SIS M651/645DX(1/3)

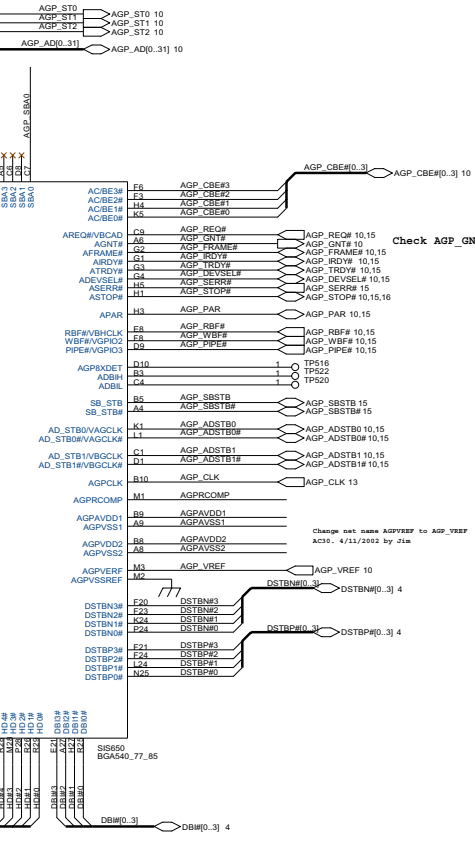
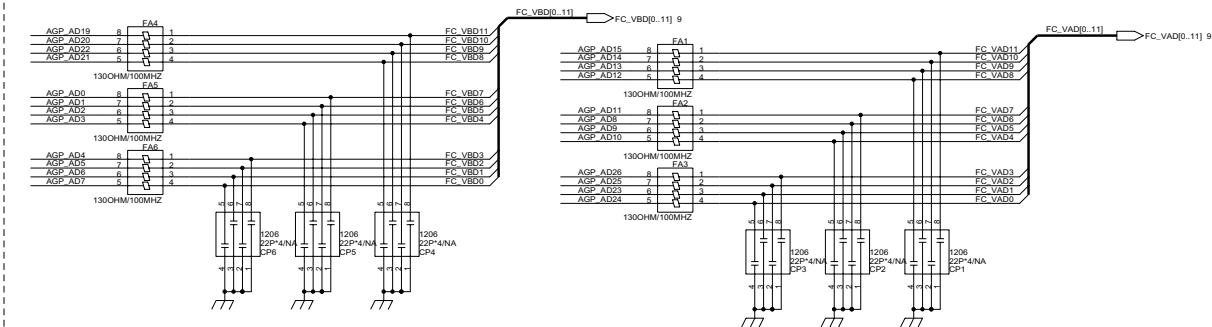
Check AGP_GNT# pull up?

Change net name AGPVREF to AGP_VREF connect to MAP17 pin
AC30. 4/11/2002 by Jim
